**From:** Guzman, Richard  
**Sent:** Monday, July 20, 2015 6:46 PM  
**To:** wanda.d.craft@dom.com  
**Subject:** NRC Staff Request for Additional Information - Proposed TS Changes for MPS2 Spent Fuel Storage (TAC No. MF0435)

DOMINION NUCLEAR CONNECTICUT INC.  
MILLSTONE POWER STATION, UNIT 2  
REQUEST FOR ADDITIONAL INFORMATION IN SUPPORT OF  
PROPOSED TECHNICAL SPECIFICATION CHANGES FOR SPENT FUEL STORAGE  
DOCKET NO. 50-336 (TAC NO. MF0435)

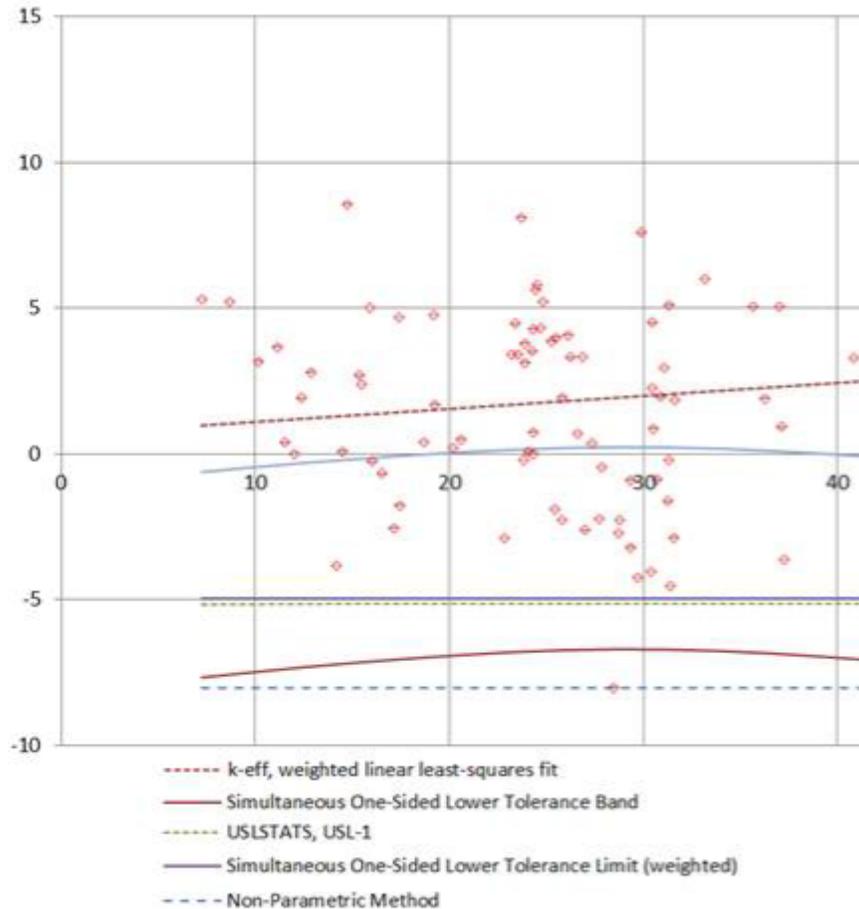
a. Table 3.1-1 of Ref. 2 contains the following errors:

i. Case 13, "NUREG Table 6.3, Nuclide dK" is listed as 0.00081. It should be 0.0081.

ii. Cases 57 through 64, incorrect values were used for "NUREG Table 6.3, Depleted Fuel k-eff" values.

iii. Case 81, "NUREG Table 6.3, Nuclide dK" is listed as 0.0008. It should be 0.0080.

Considering items a. through e., the licensee should review and revise the fuel depletion analysis bias and uncertainty and the burned fuel criticality analysis presented in Ref. 2.
